PLANS AND DOCUMENTS referred to in the PDA DEVELOPMENT APPROVAL

AMENDED IN RED

Project Eagle Farm Precinct

Drawing Development Summary - Stage 1

Drawing Stage 1 - Ground Floor Mezzanine Plan

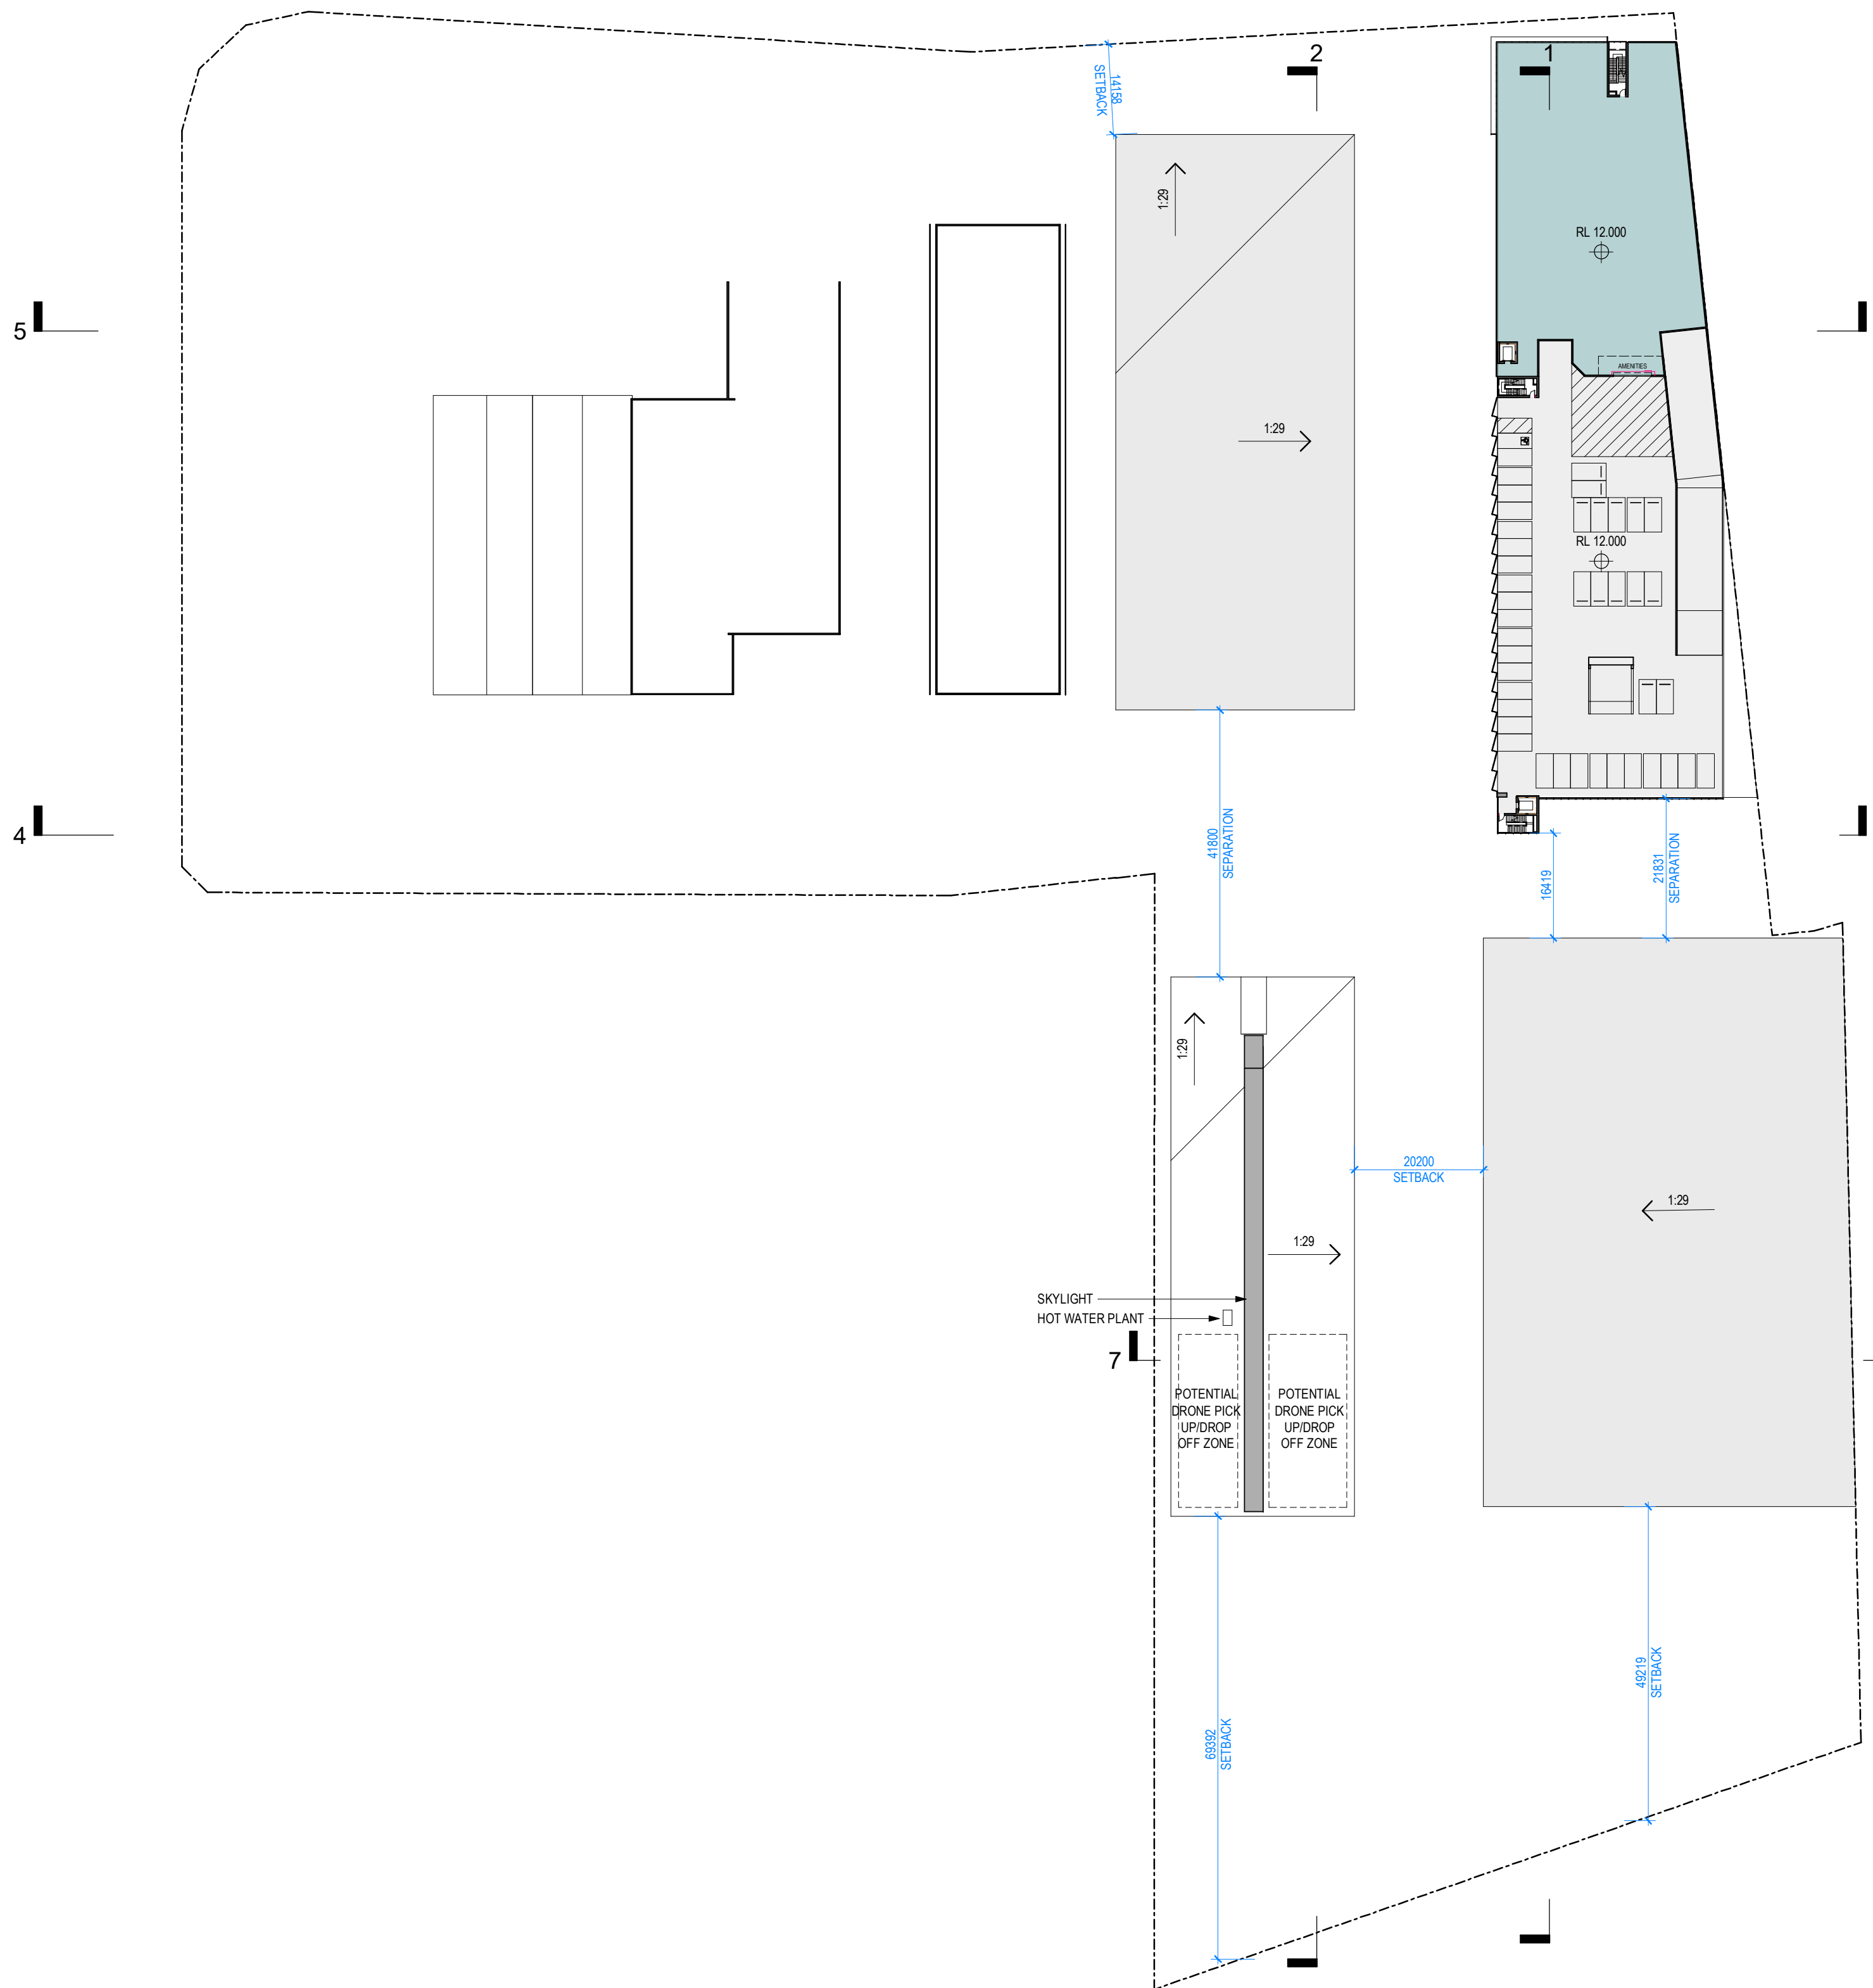
Productive garden to be considered as part of contamination, soil vapour, and air quality considerations. Only to be established if demonstrably safe as per documentation prepared to satisfy contamination, vapour management, and air quality conditions.
